- Change of fuse approval marking

Product Change Notification					PCN SPT 3.6x10 - change of approval logo		
owner	creation date	release date	released by	change order	rev	page	D10-102-775
kooka	07.08.2026	10.08.2026	jingkl		A	1 of 2

3 Detailed description of change

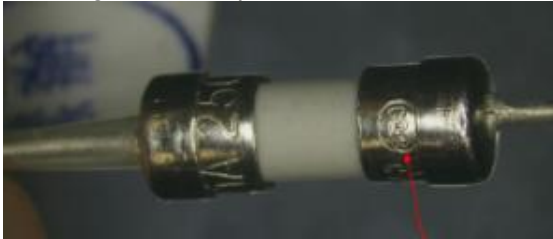
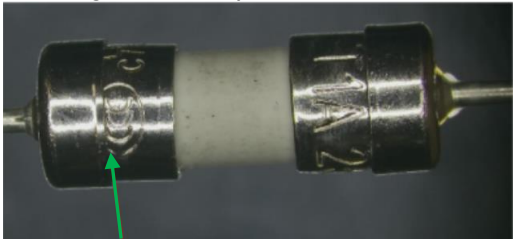
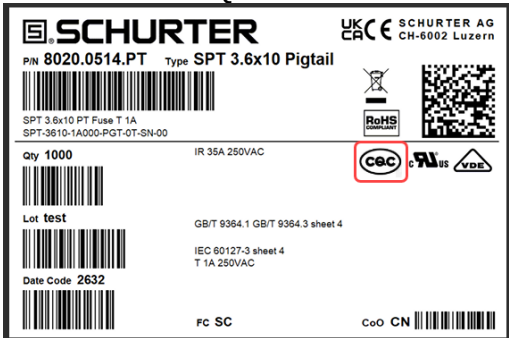
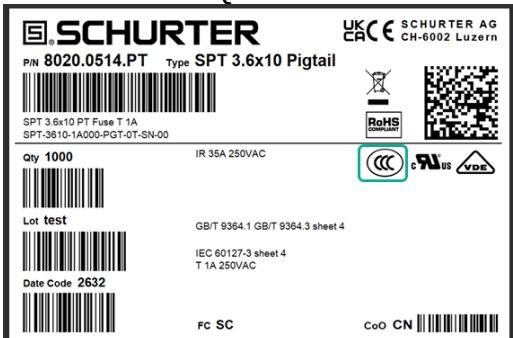
Current	After
CQC logo on the cap: 	CCC logo on the cap: 
Label on the SPQ: 	Label on the SPQ:

- Requested by CCC: The series of product shall be marked with CCC because of the CCC self-declaration.

| ☒ Label | Inform incoming inspection about the changes on fuse and label . |
